**6.0 TRAFFIC AND TRANSPORTATION COMMENTS AND RESPONSES**

**6.1 FEIS Conservation Plan**

**Figure 6-1: Traffic Regulatory Signs**  
 Lake Blooming Grove  
 Town of Blooming Grove, Orange County, New York  
 Base Map: US DOT Planimetric Map  
 Approx. Scale: 1" = 1,700'

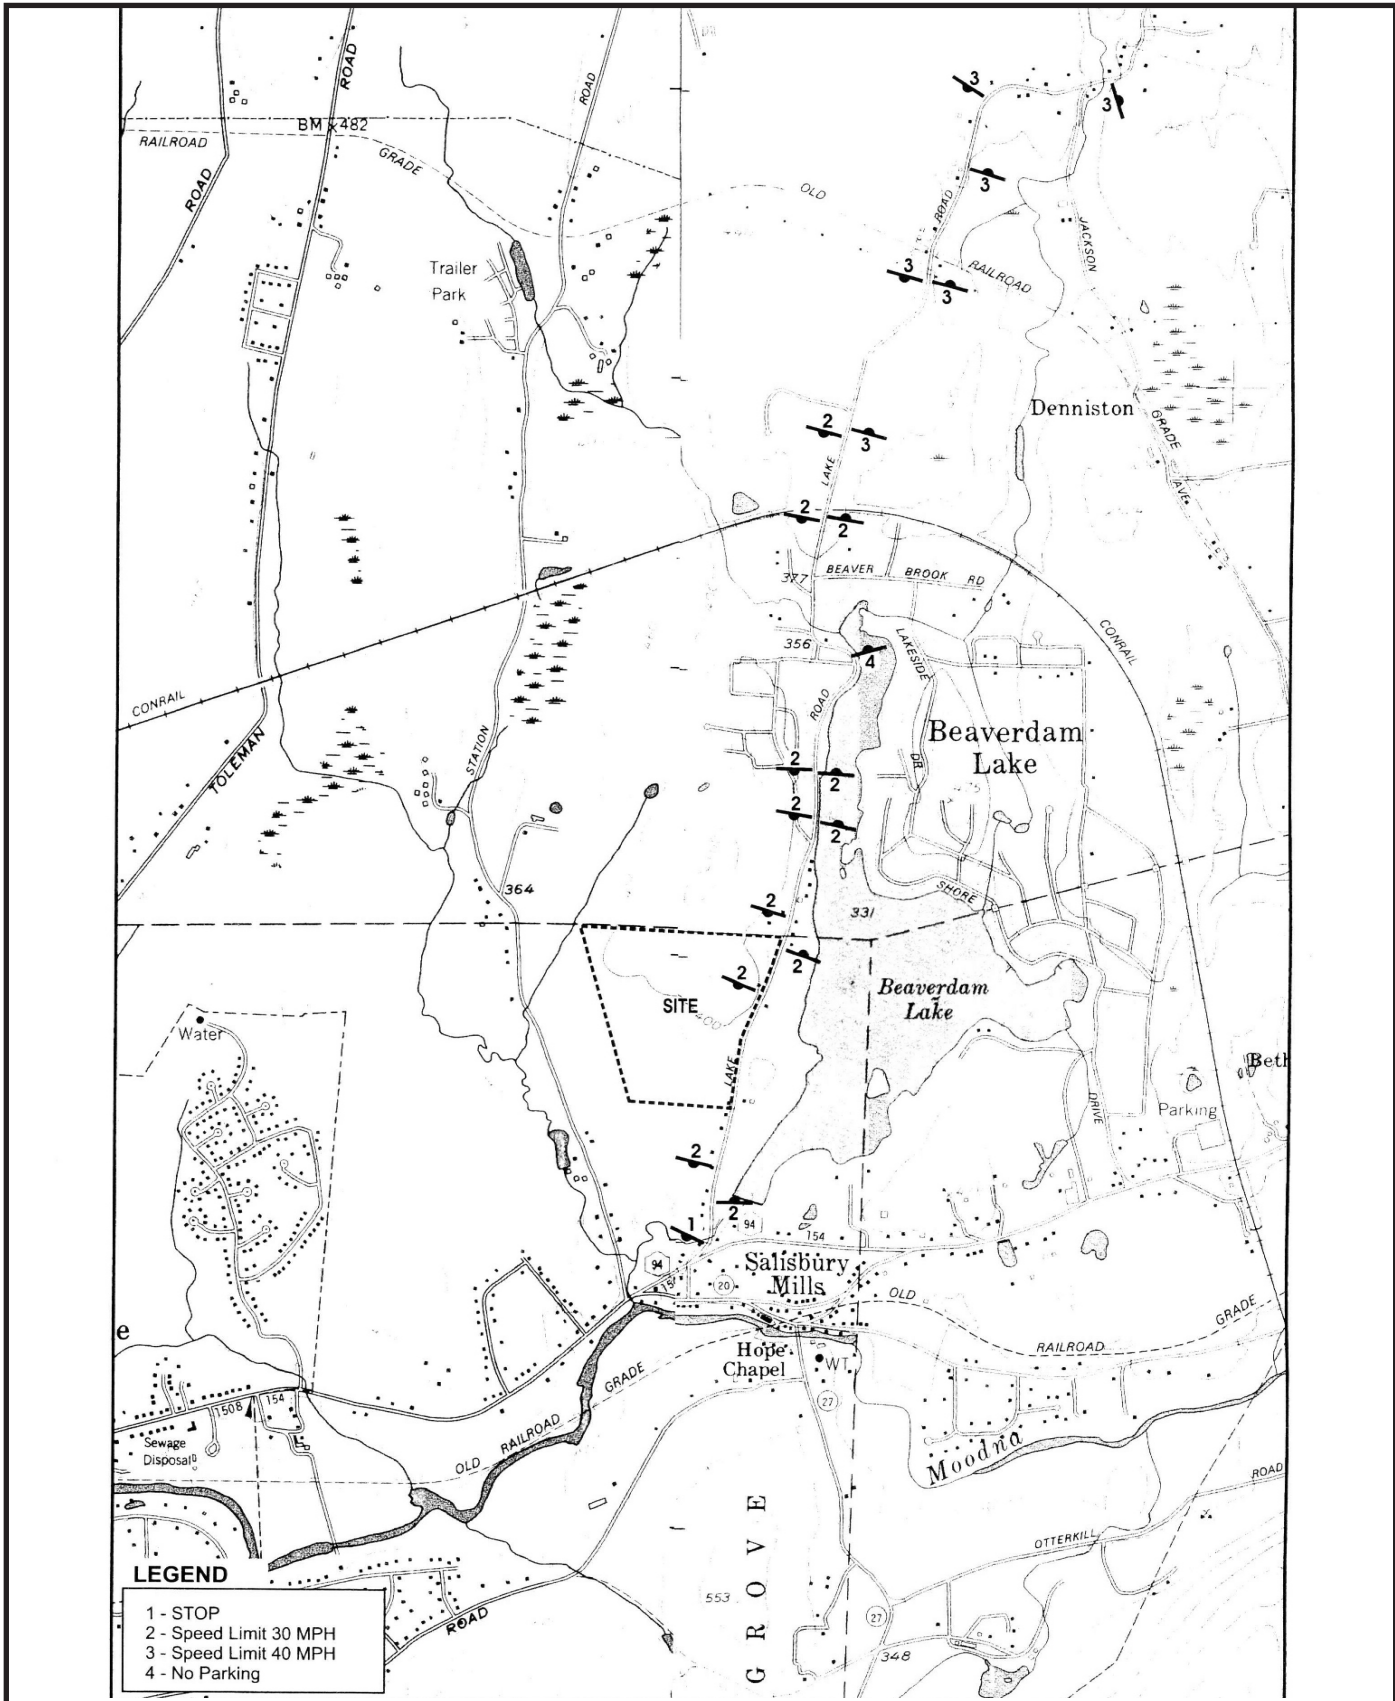
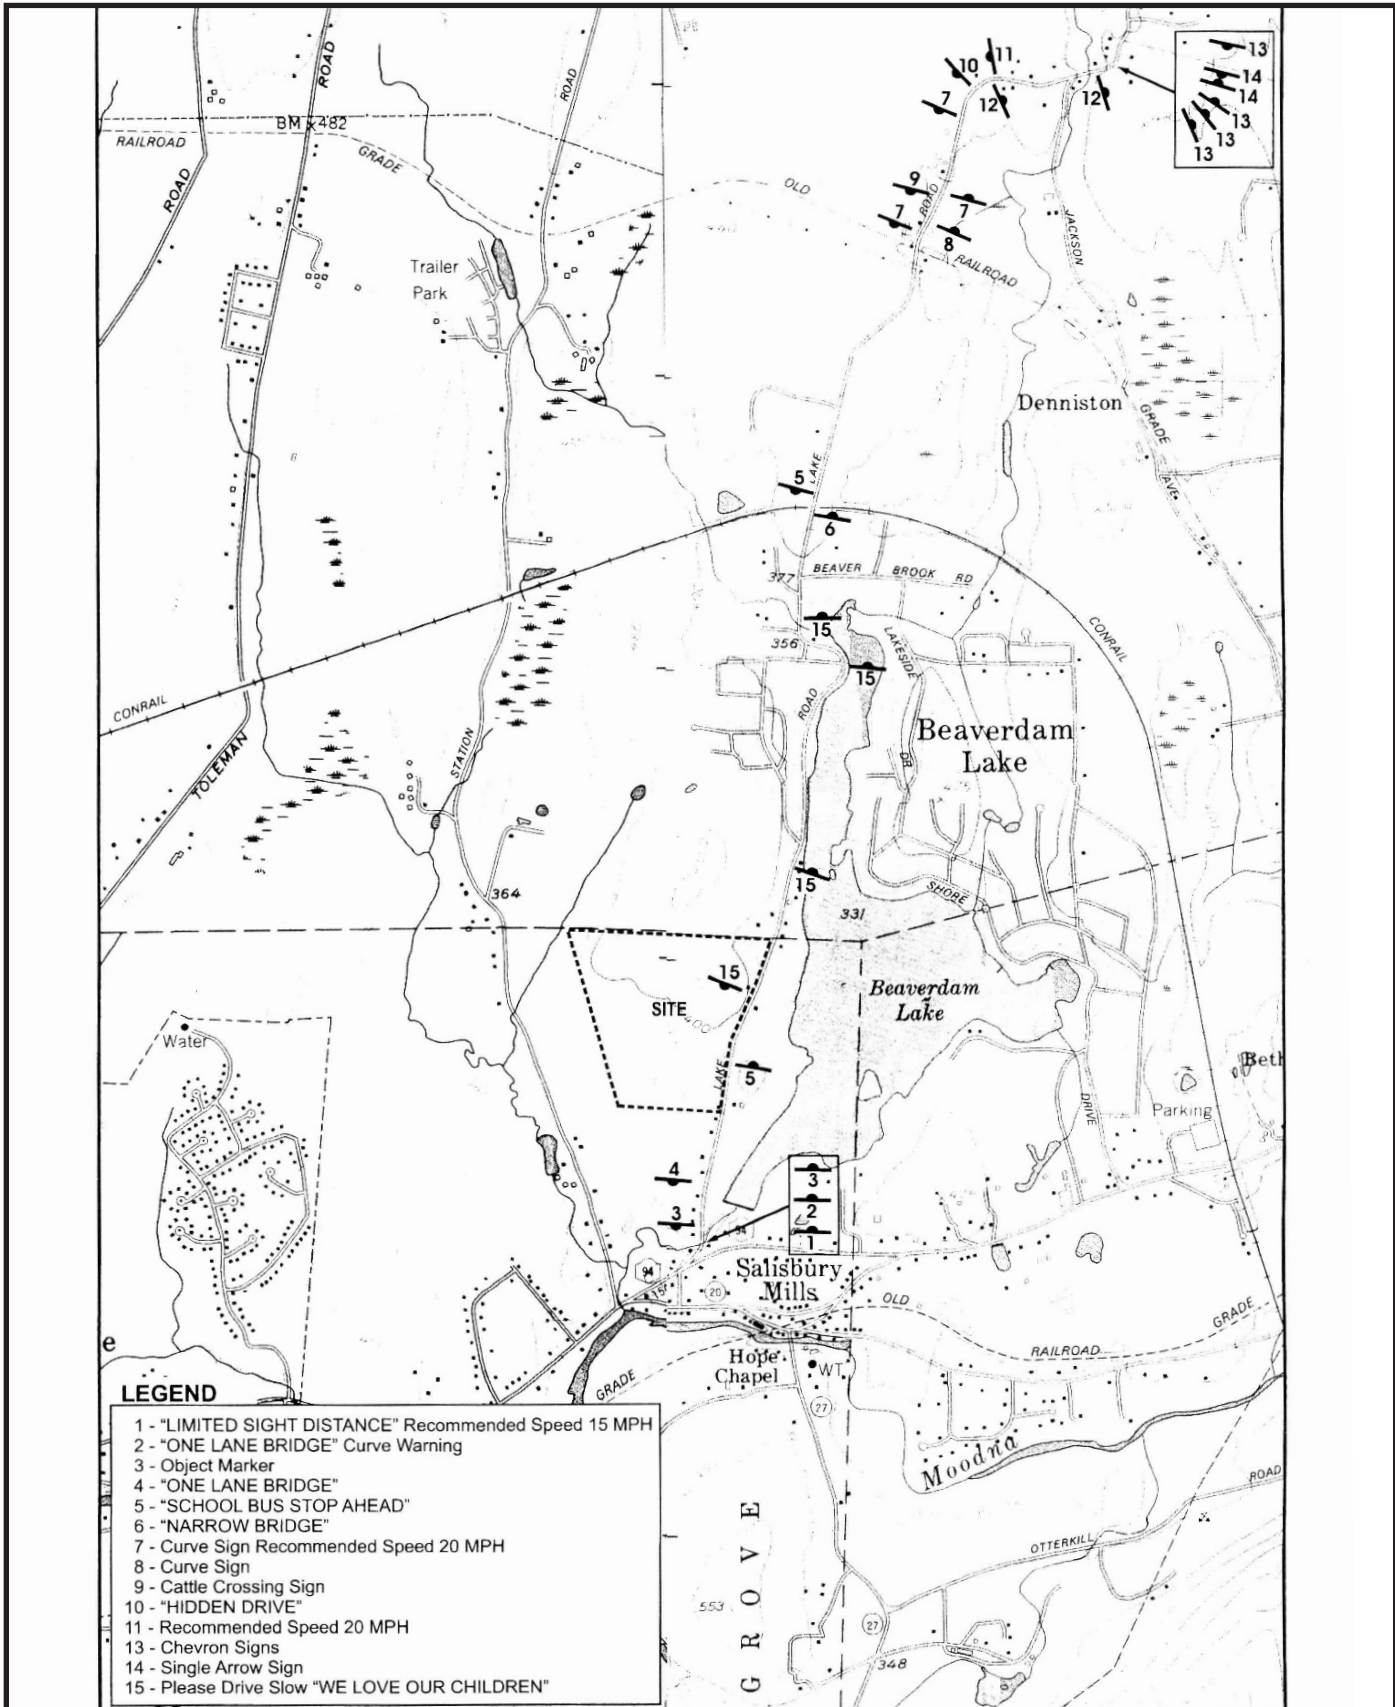
The fact that they did a study at the corner of the light for the traffic does not [address] the questions that were even part of the initial scoping session and also the Pos. Dec. that the Planning Board issued. That particular stretch of road is a safety hazard right now with the amount of traffic it's got right now. They did nothing in that DEIS to even address that question. They took a look at where it meets Route 94 and on the other end, Beaver Brook. They looked at two ends there and that was it. They said nothing about the traffic safety on the road itself. If you can find it please show it to me. I feel that the environmental impact study is supposed to address what's its scoping. It didn't. I'm not necessarily for this project.

**Comment 6-7 (Letter #1, Fine and Associates, Beaverdam Lake Civic Association Data Base for Public Hearing, June 23, 2004):** What is the plan to address the poor road conditions and resultant safety?

*This analysis was completed as part of the DEIS. The Scope also required a description of Lake Road, "with regard to width, condition, capacity, maintenance, ownership and any constraints such as bridges." The current condition of Lake Road was described in the DEIS. In response to the DEIS comments regarding the physical condition of Lake Road, a more thorough evaluation of the physical conditions on Lake Road was conducted for this FEIS including, pavement condition and signage. An inventory of existing traffic warning and regulatory signage has been conducted along Lake Road (Figures 6-1 and 6-2).*

**Response 6-7:** Lake Road is a Town Road, and is the responsibility of the Towns of Blooming Grove and New Windsor, respectively. The applicant has analyzed the impact of adding additional traffic to the transportation network and has documented the existing road conditions. A review of the physical condition of Lake Road has identified conditions which are not equal to Town Standards. This documentation included an inventory of roadway signage. Existing signs are shown in Figures 6-1 and 6-2. A summary of signage on Lake Road and recommendations for improvement is provided in Appendix B.

**Figure 6-3: Road Widths**  
 Lake Blooming Grove  
 Town of Blooming Grove, Orange County, New York  
 Base Map: NYS DOT Planimetric Map  
 Scale: 1" = 2,000'

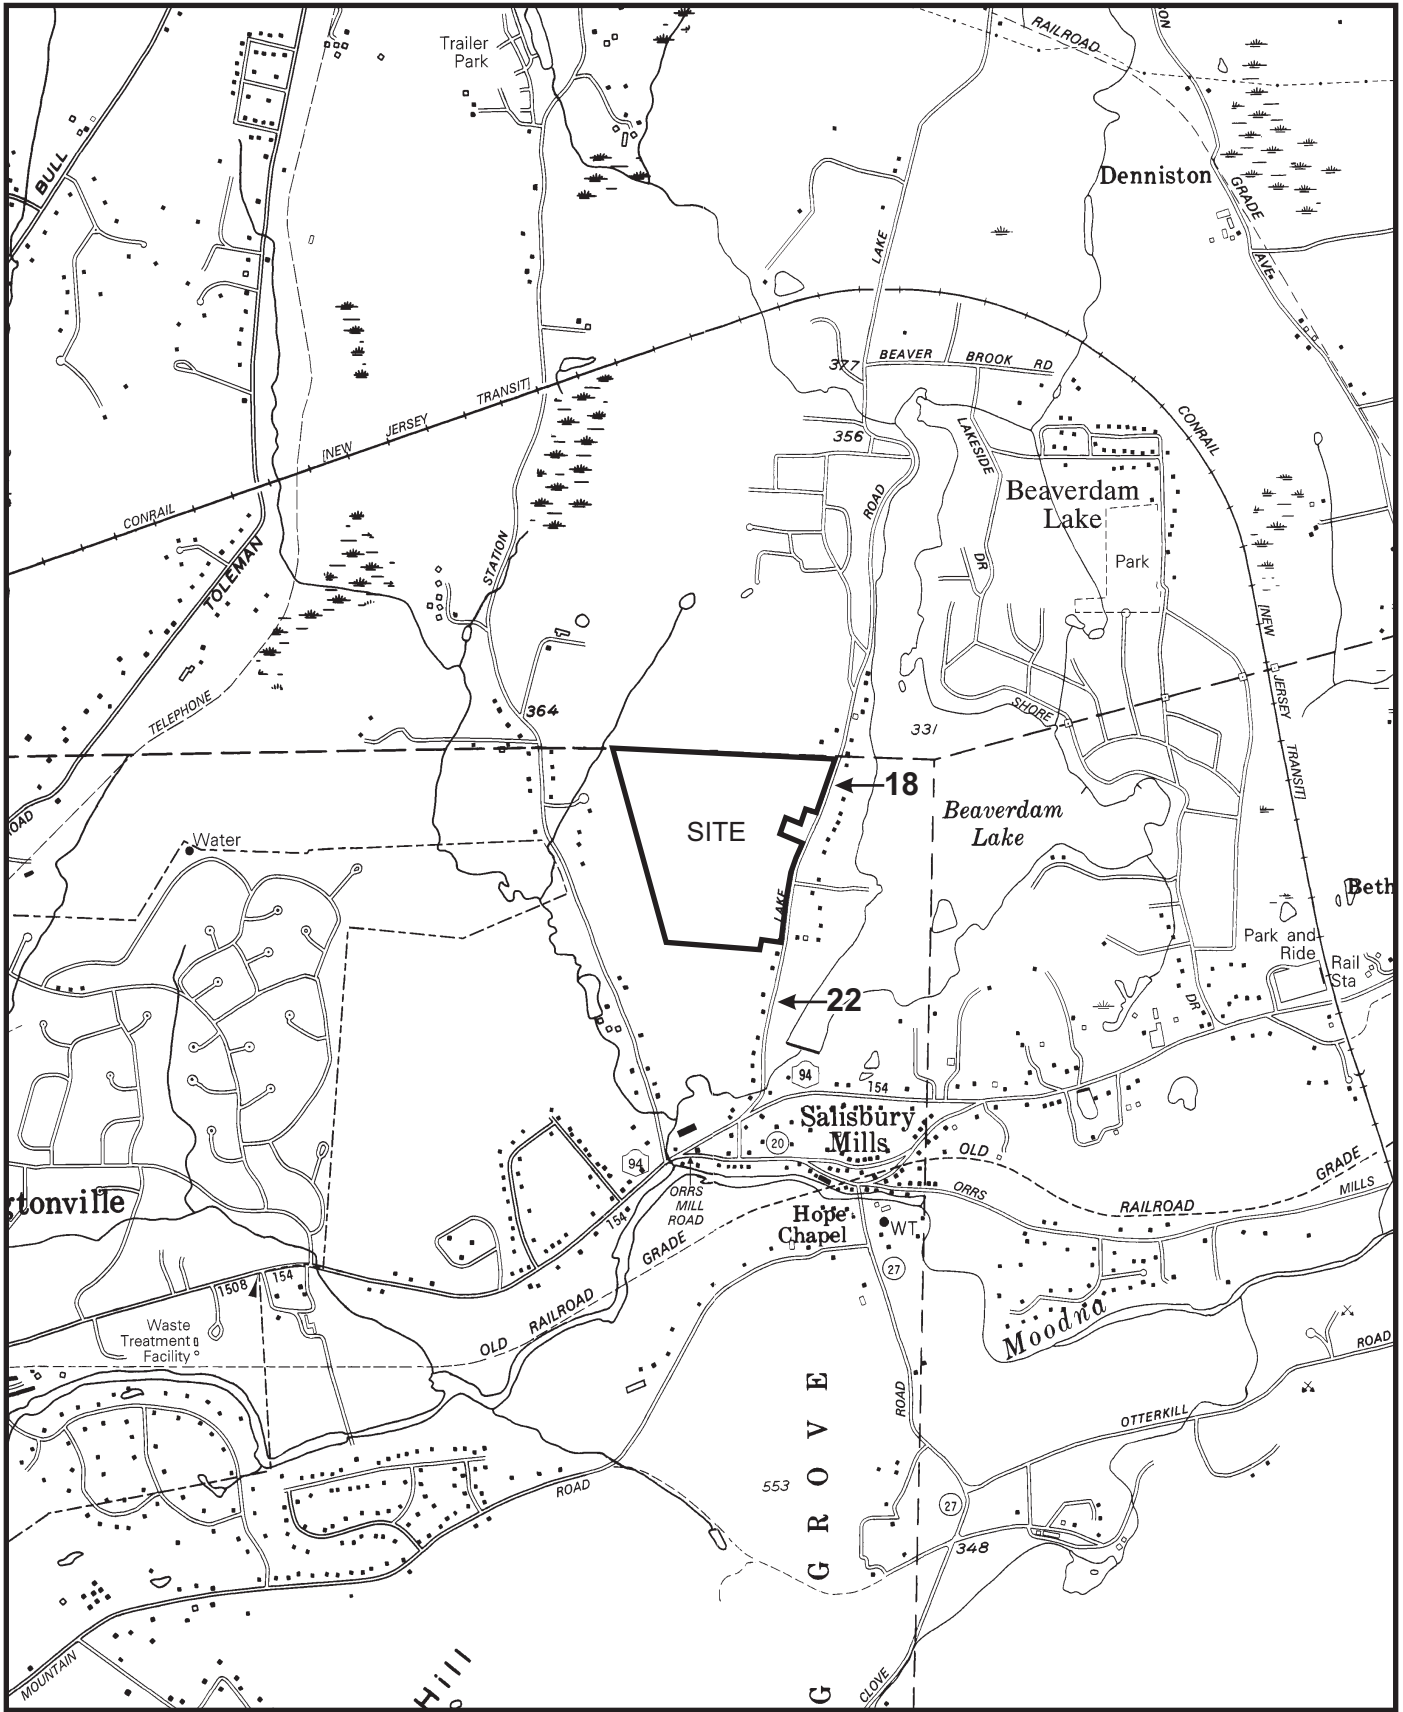
**Comment 6-11 (Letter #9, Town of Blooming Grove Planning Board Plan Review, July 26, 2004):** What are the size, capacity, condition, maintenance and ownership of the local transportation facilities? What is the existing condition of Lake Road; width, shoulders, vertical and horizontal alignment? What is the level of safety for Lake Road?

*Roadway conditions were reviewed along Lake Road. Lake Road is one lane in each direction and is generally 18 to 22 feet wide.*
